NEW FEATURES

■ EXTERIOR AND INTERIOR

1. Exterior

Front View

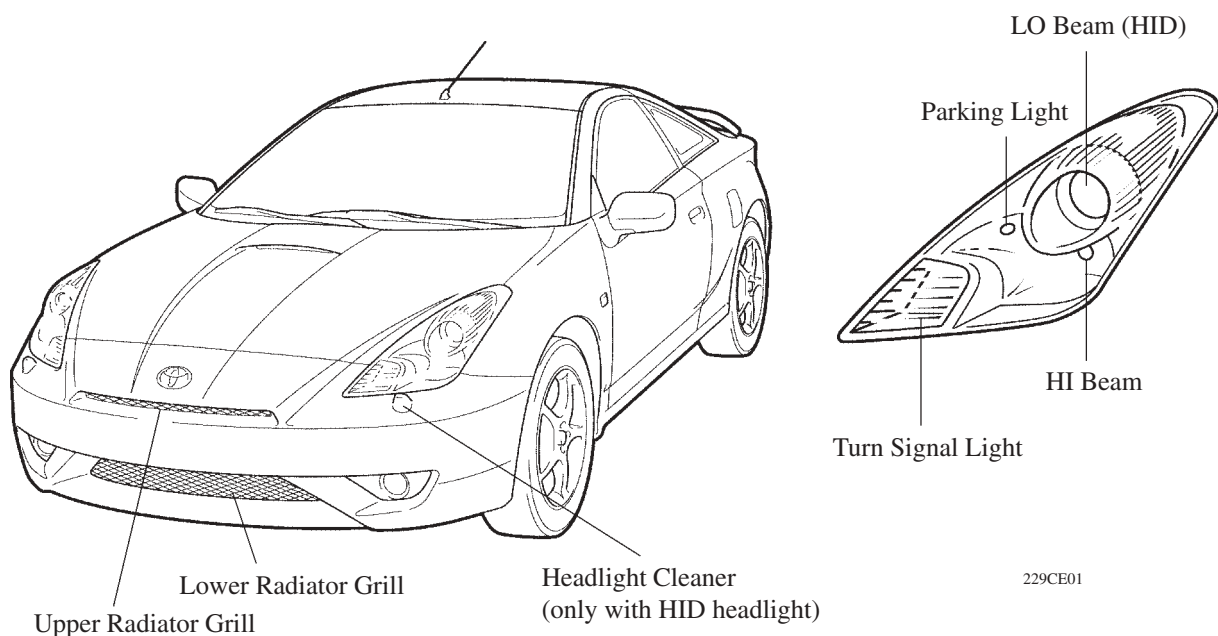
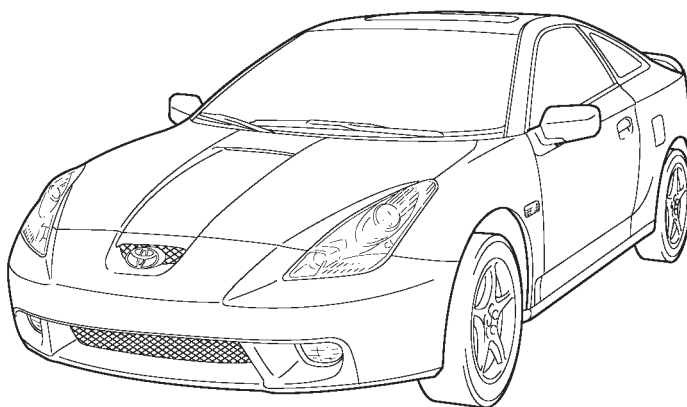
- The design of the upper and lower radiator grilles has been changed to emphasize the wideness and the low center of gravity.
- HID headlights are available as an option in order to enhance the high functionality image. Along with the installation of the HID headlights, the bulb replacement procedure has been changed. For details, see the Celica Chassis & Body Repair Manual Supplement (Pub No. RM981E).

Rear View

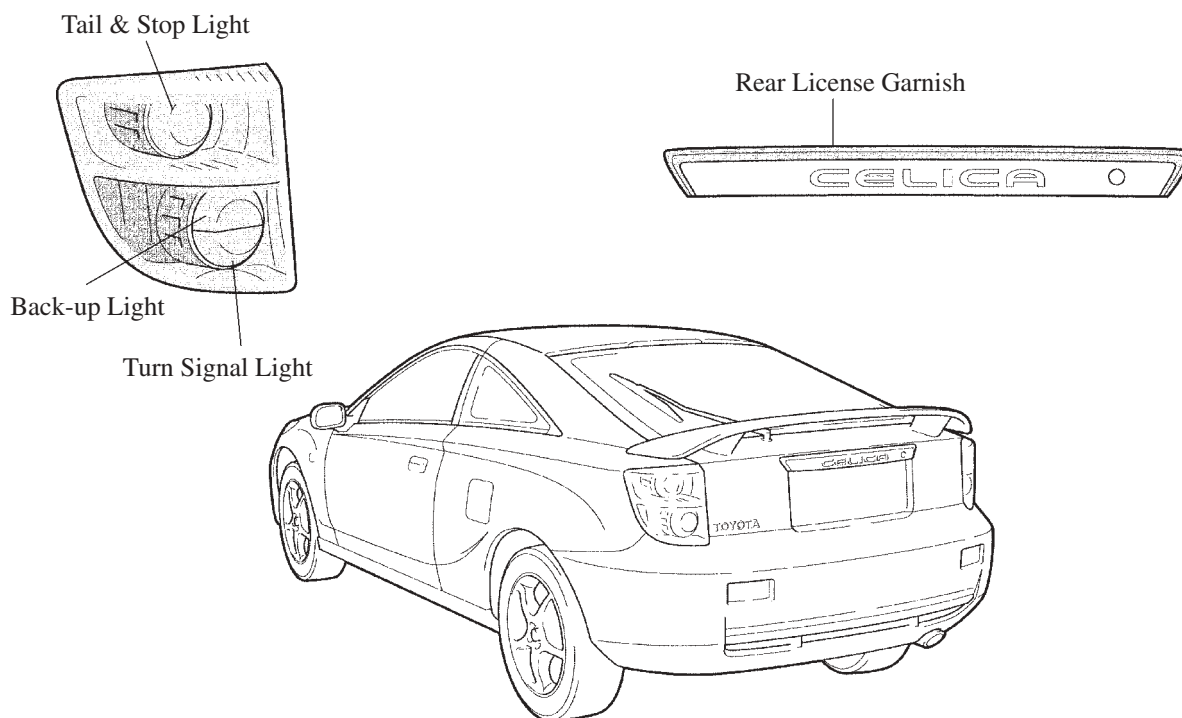
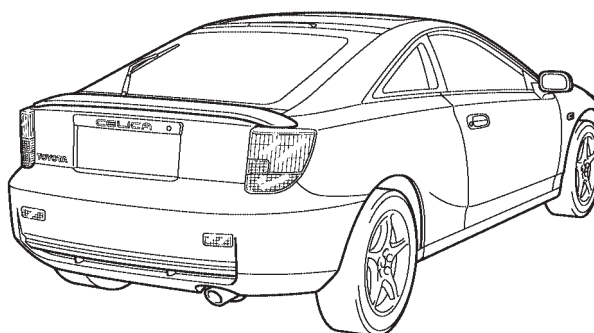
- The design of the rear combination lights has been changed to emphasize the sporty and futuristic look.
- The rear license plate garnish on the Australia model has been changed to emphasize high quality.
